Subj: DELIVERY OF RESPONSE TO COMMENTS ON THE DRAFT SITE
ASSESSMENT REPORT, IRP SITE 16, FORMER MARINE CORPS AIR
STATION (MCAS) EL TORO, CALIFORNIA

**Response to Comments on Site Assessment Report, IRP Site 16,
Former Marine Corps Air Station, El Toro California Revision 0, dated March 30, 2004**

SOUTHWEST DIVISION NAVAL FACILITIES ENGINEERING COMMAND	
FORMER MCAS EL TORO, CA	
MAXIMUM TPH-d CONCENTRATION IN SOIL AT 5 TO 10-FOOT DEPTH IRP SITE 16	
FILE NO. SITE_16-004	DATE ATTACHMENT 4 8/16/04

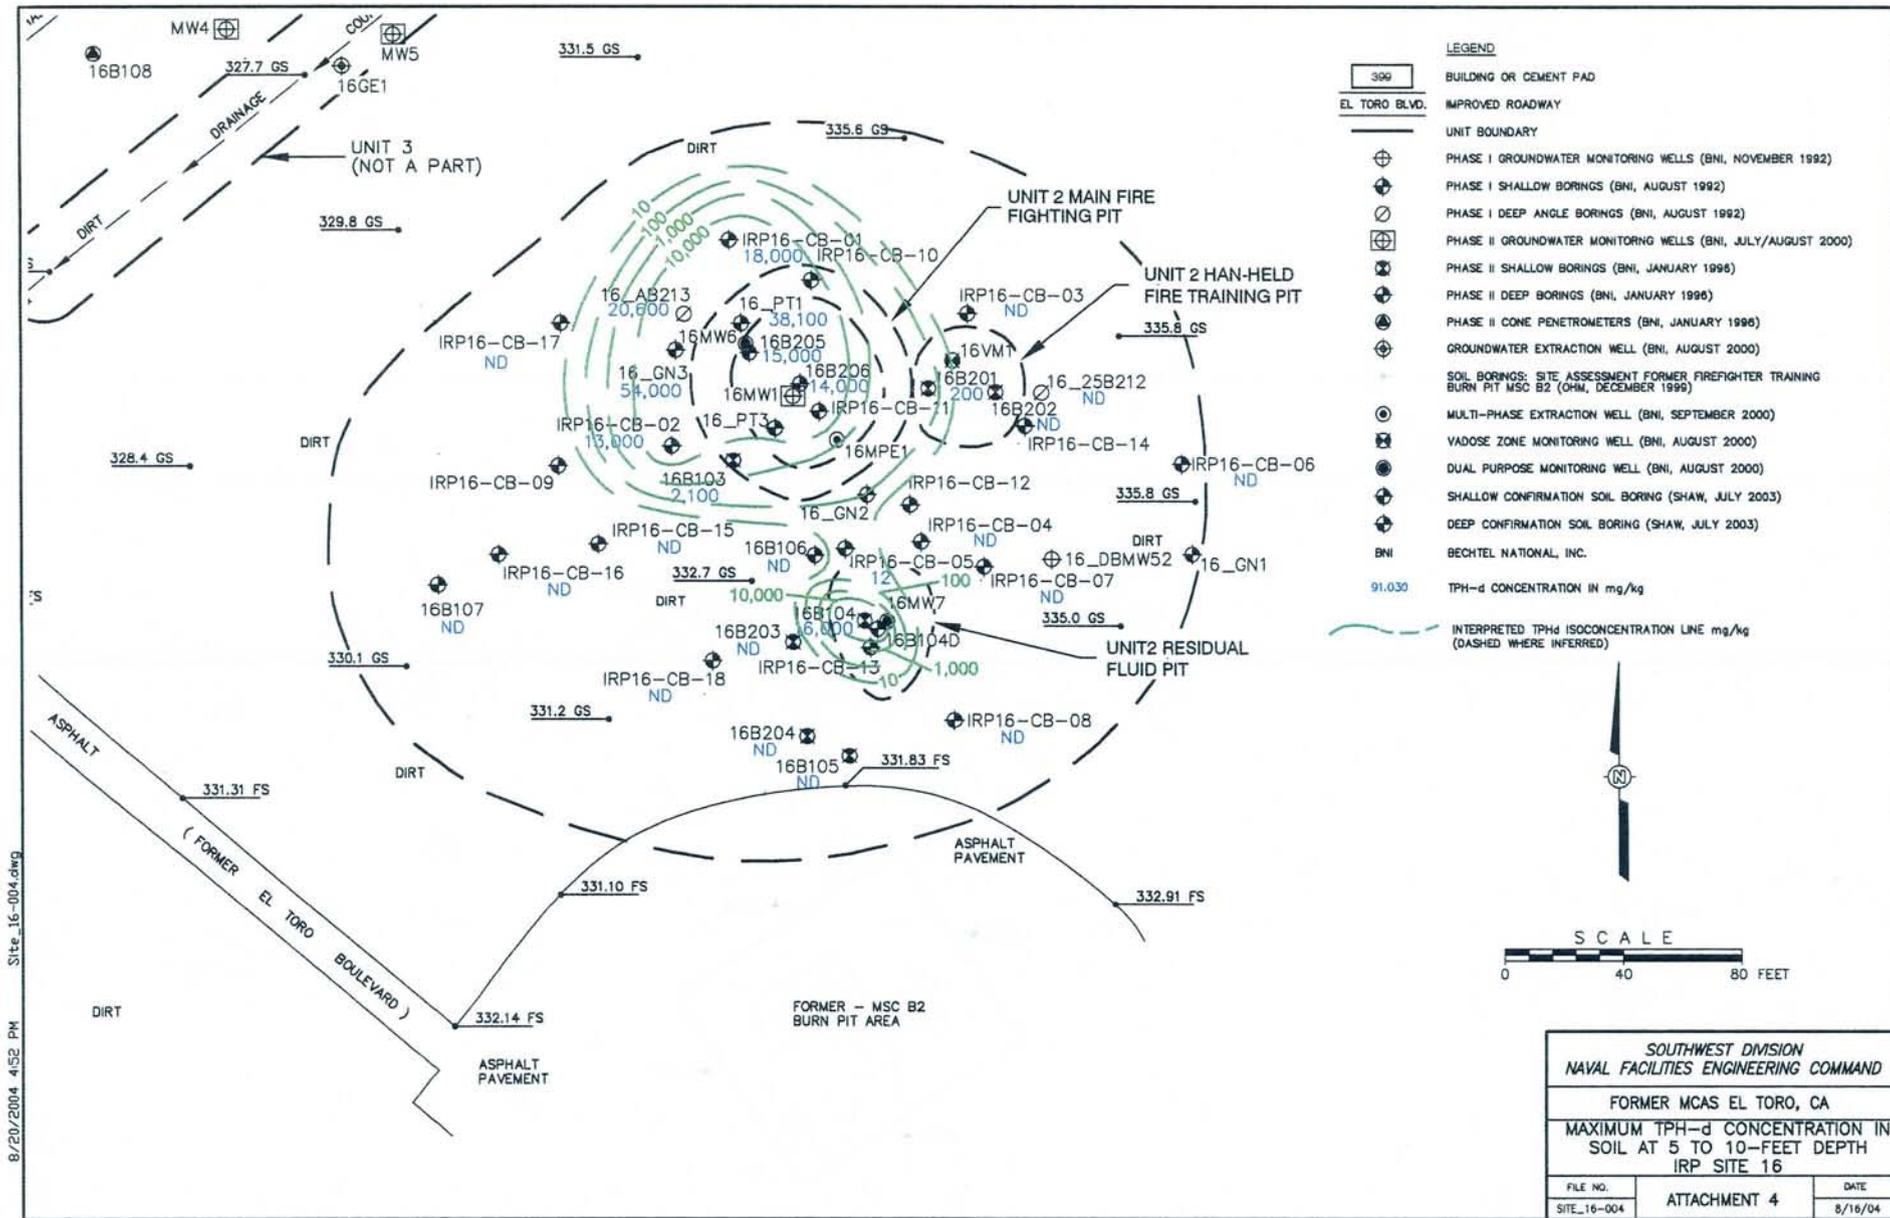
2.		There is no figure for TPHd in soil at depths of 0-20 feet below ground surface (bgs), which would be the interval most useful for depicting the contamination at the hand-held fire-training pit as well as the down gradient northwestern edge of the main pit plume. Please provide a figure for shallow soil, especially since TPH at IRP16-CB-01 and IRP16-CB-02 is high.	<p>Comment acknowledged. A new Figure showing the distribution TPHd and in the shallow soil (5 to 10 feet depth) has been prepared.</p> <p>A copy of the new map is included here in as Attachment 4</p>

SOUTHWEST DIVISION NAVAL FACILITIES ENGINEERING COMMAND		
FORMER MCAS EL TORO, CA		
CROSS-SECTION A-A' TPH AND TOTAL VOCs IN SOIL		
FILE NO.	FIGURE 6	DATE
SITE_16--002		8/16/04

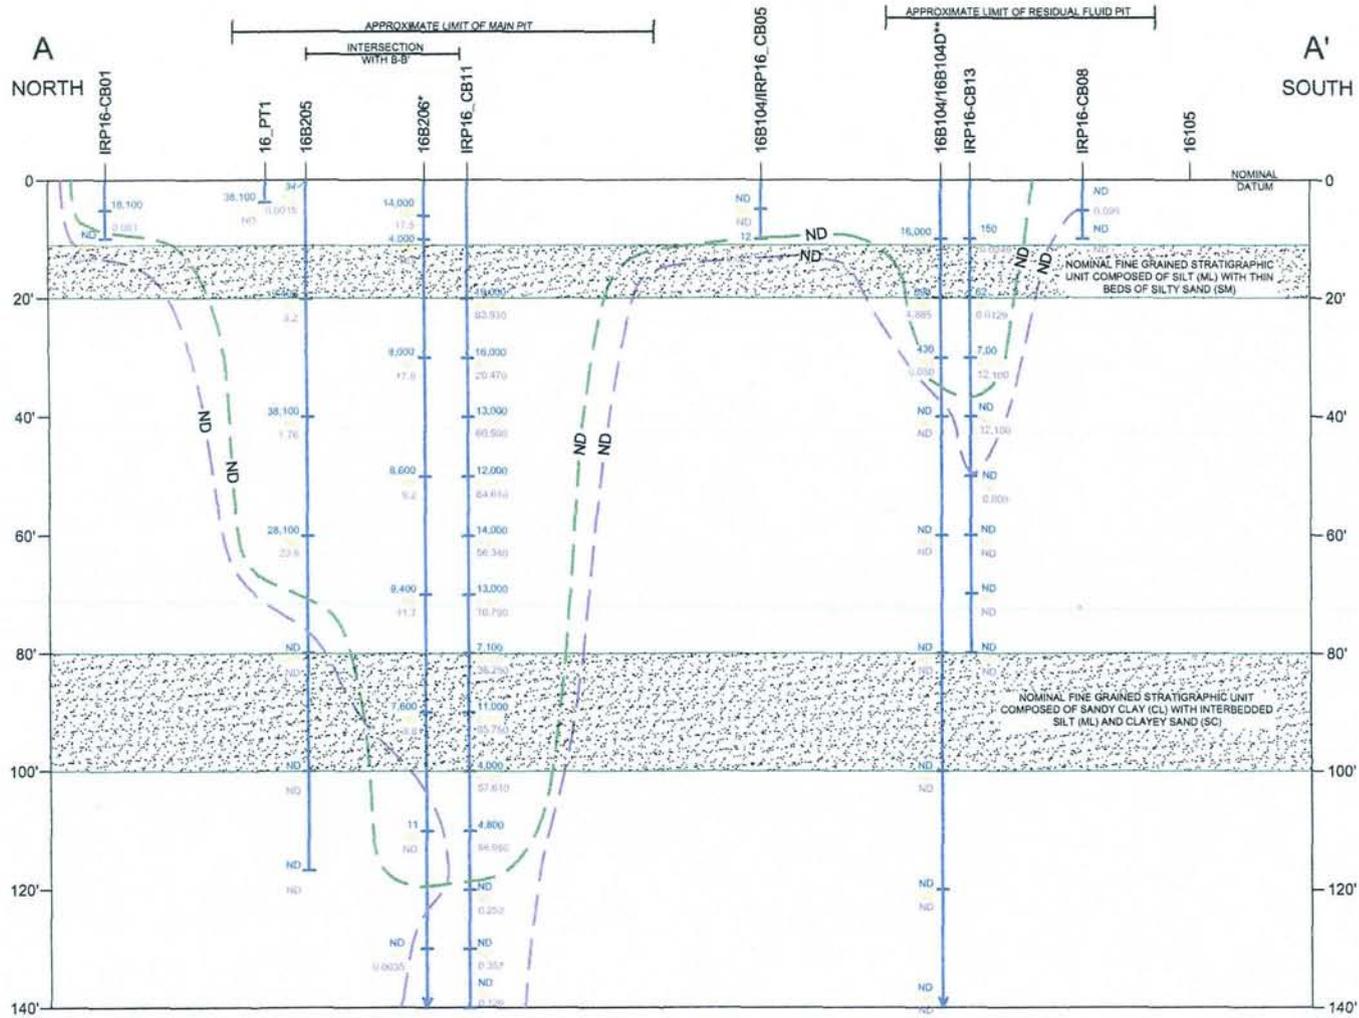
Specific Comments from, Nicole Moutoux, Project Manager, U.S. Environmental Protection Agency, Region IX, dated May 13, 2004			
1.	Section 5.1, Site Geology, Page 5-1;	This section includes a written description of the general site stratigraphy rather than providing a visual representation of the stratigraphy. As there are lithologic data for the borings, it would be helpful to have that data mapped to assess the potential for vertical and horizontal migration of TPH and VOCs, Please provide a stratigraphic cross-section.	Comment acknowledged. The existing cross section with stratigraphic information has been revised to include more detailed information and included here in as Attachment 5.

6.	Section 5.4, Discussion, Page 5-4	It is stated that VOCs at low concentrations are more widely distributed than TPH, but that they are likely still entrained together, as the detection limit is much lower for VOCs. Rather than simply providing numbers of samples that apparently have similar TPH and VOC contamination problems it would be very helpful to have a visual representation of the delineation of the VOC contamination to compare to the extent of the TPH plumes. Please consider providing this figure for comparison.	Comment acknowledged. The existing cross section with stratigraphic information has been revised to include more detailed information such as VOC distributions. The changes to the cross sections are included in Attachment 5.

Comment No.	Section/Page Number	Comment	Response
Specific Comments from, Dave Murchison, R.G., Engineering Geologist, Department of Toxic Substance Control, dated May 14, 2004			
1.	Figures 6 and 7, Cross-sections A-A' and B-B'.	There is an apparent error in the depth scales on these figures. The deepest depth should probably be 140' rather than 40'.	Comment acknowledged. Revised Figures 6 and 7 are included in Attachment 5.

SOUTHWEST DIVISION NAVAL FACILITIES ENGINEERING COMMAND		
FORMER MCAS EL TORO, CA		
CROSS-SECTION B-B' TPH AND TOTAL VOCs IN SOIL		
FILE NO.	FIGURE 7	DATE
SITE_16-003		8/16/04

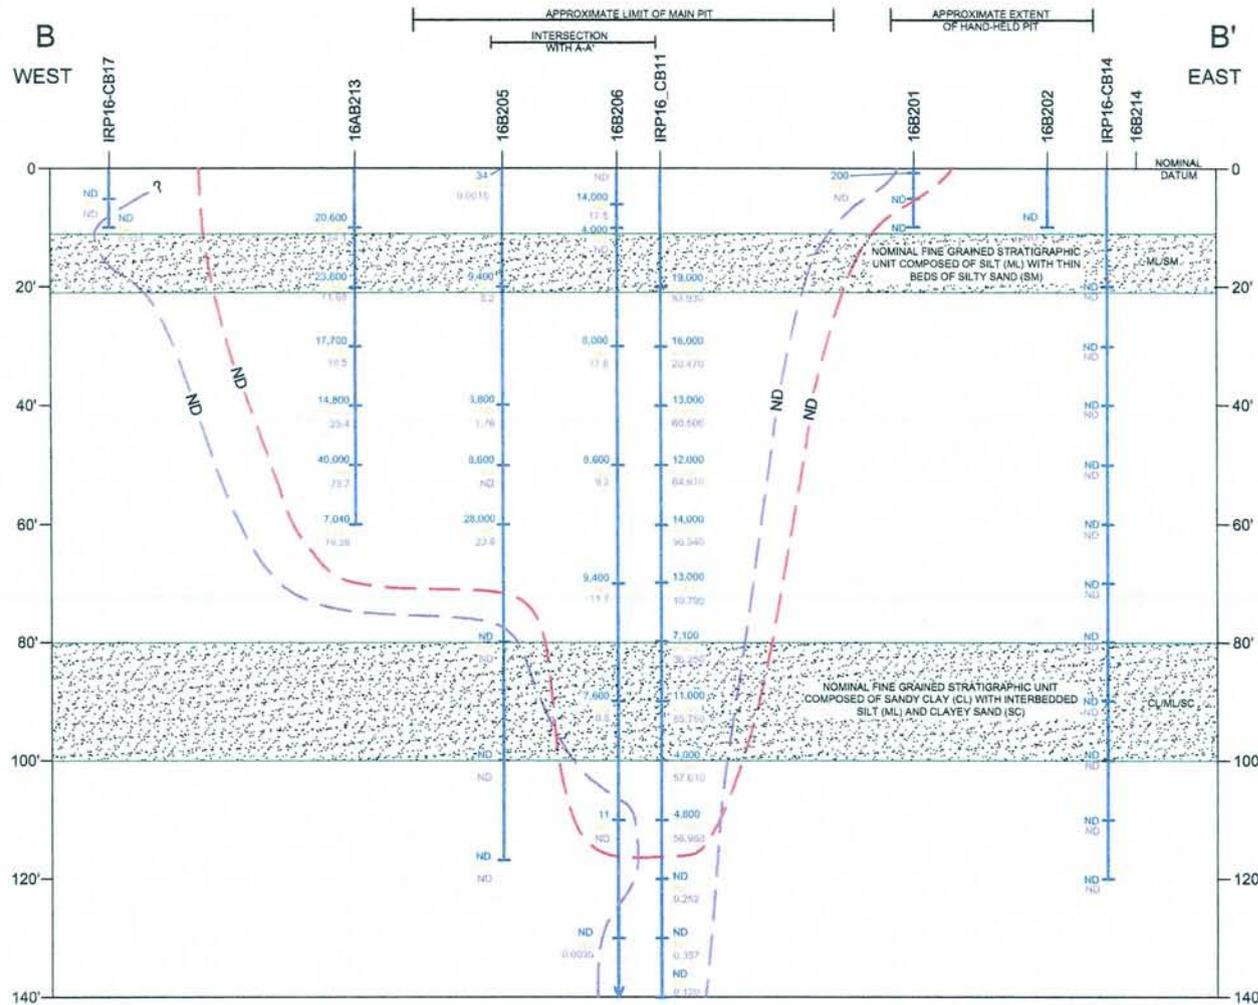
10.	Figure 7, Cross-Section B-B\ TPH in Soil:	Boring 16AB213 ends at a total depth of 60' bgs and TPH concentrations of 7,040 mg/kg (TPHd) and 4,690 mg/kg (TPHg). Thus, the extent of vertical contamination at this boring log is incomplete. Please explain how the non-detect isocontour was drawn around this boring, and how this data gap will be addressed.	Comment acknowledged. The adjacent boring 16B205 (~ 24' distant) has an even greater concentration at 60' depth of 28,000 mg/kg; however, at 80' depth analysis did not detect the presence of TPH constituents. The contour was drawn reflecting the nearest control point.

Attachment 7
New Figure, Conceptual SVE well and Screen Intervals Cross
Section

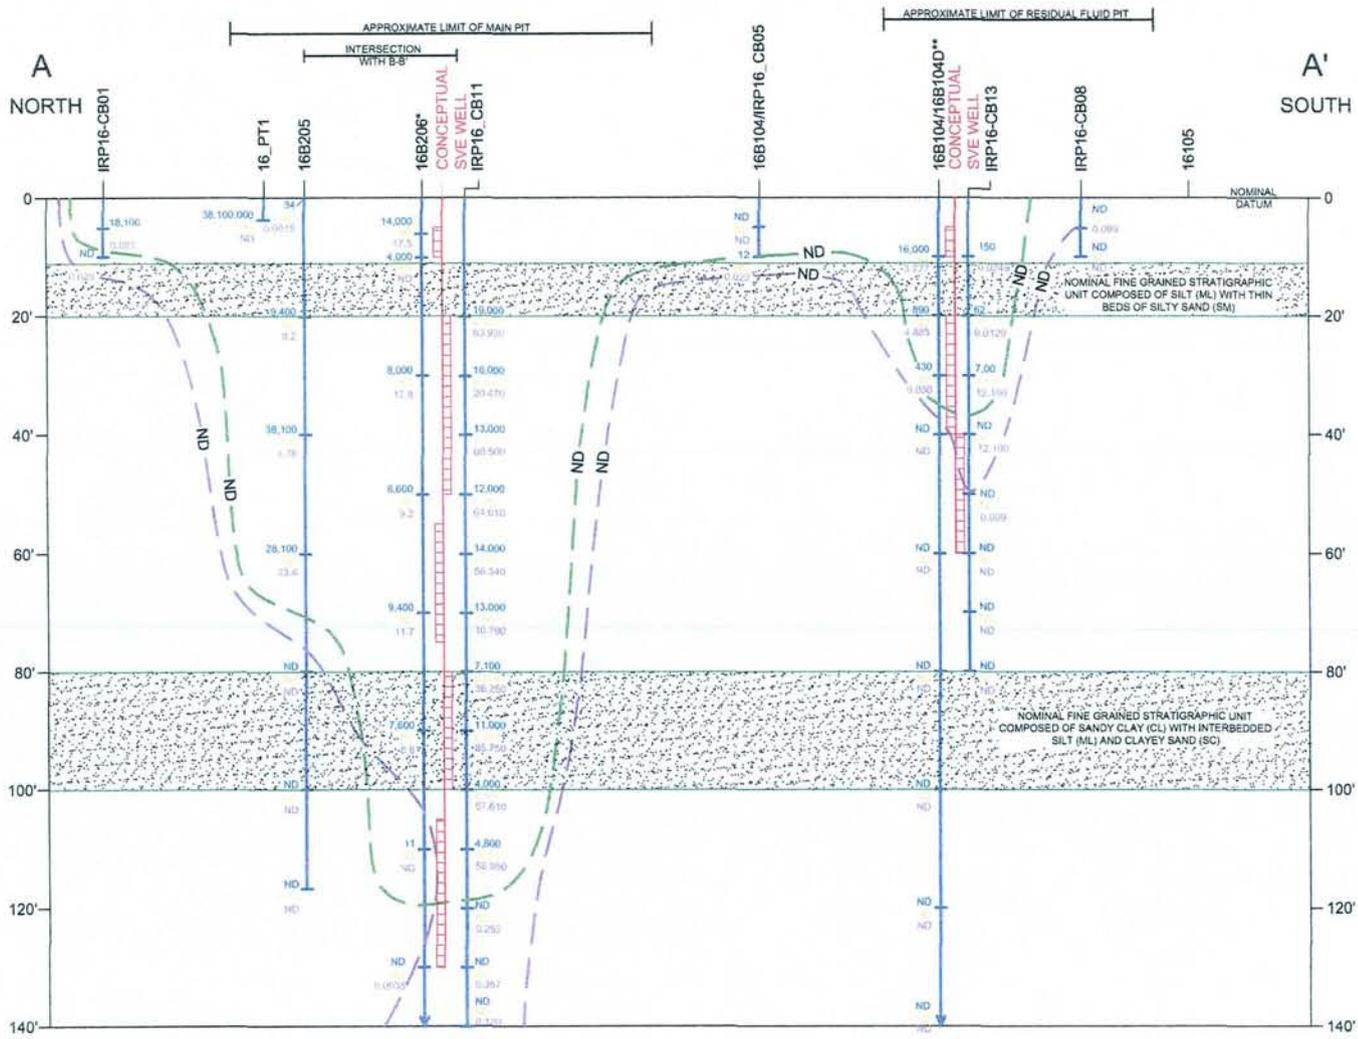
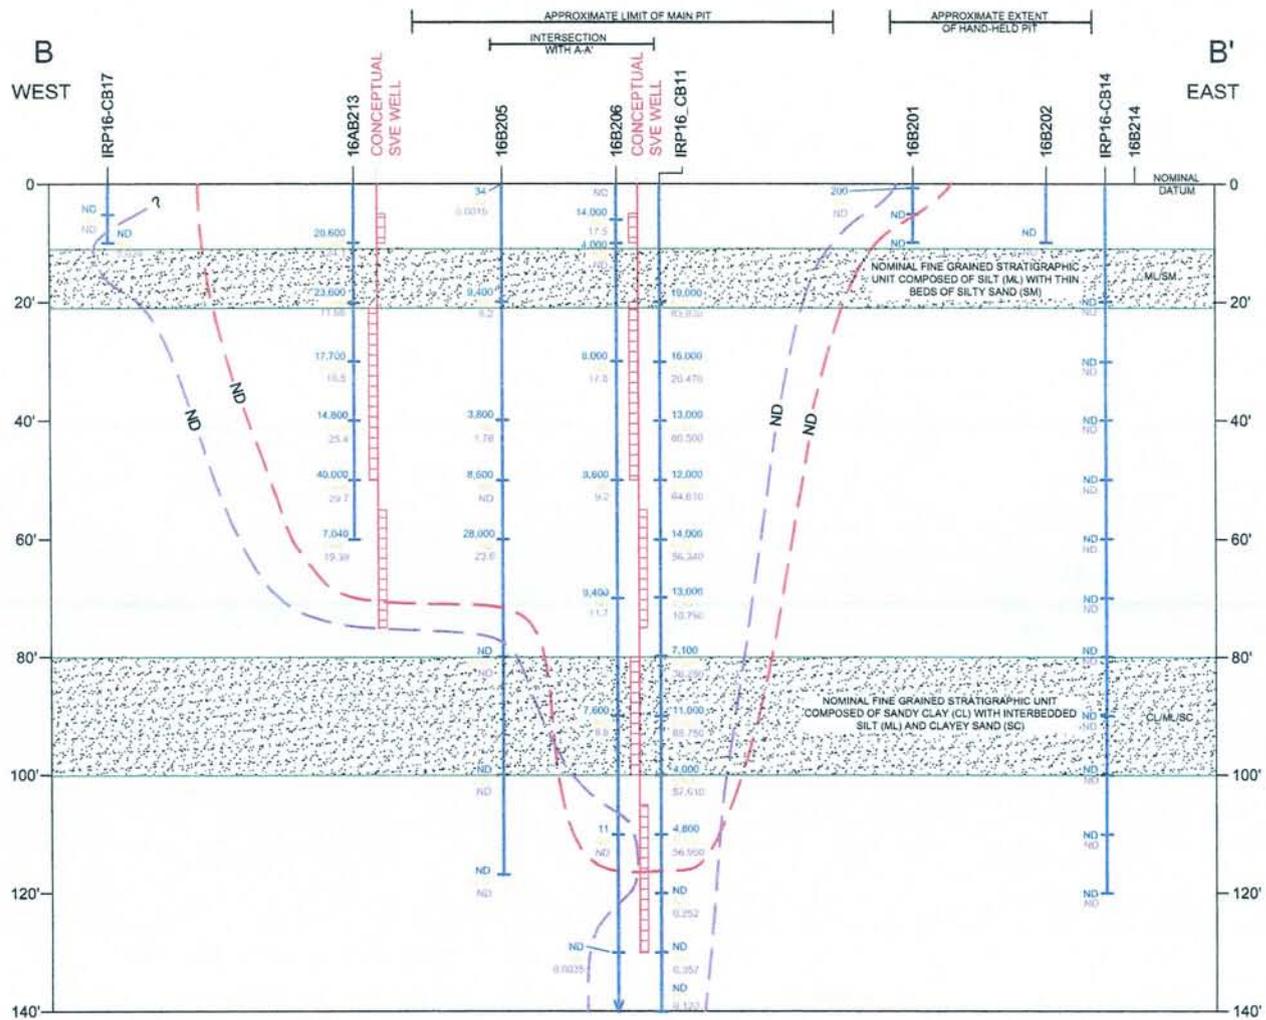
7.	Section 7.0, Discussion and Recommendations, Page 7-2	Again, the last paragraph discusses the need for three or four separate screened intervals in nested or clustered wells to remediate soil gas because of differences in permeability. It would be helpful to have a stratigraphic cross-section to refer to.	Comment acknowledged. A drawing showing conceptual construction or distribution of wells has been prepared and included in Attachment 7.
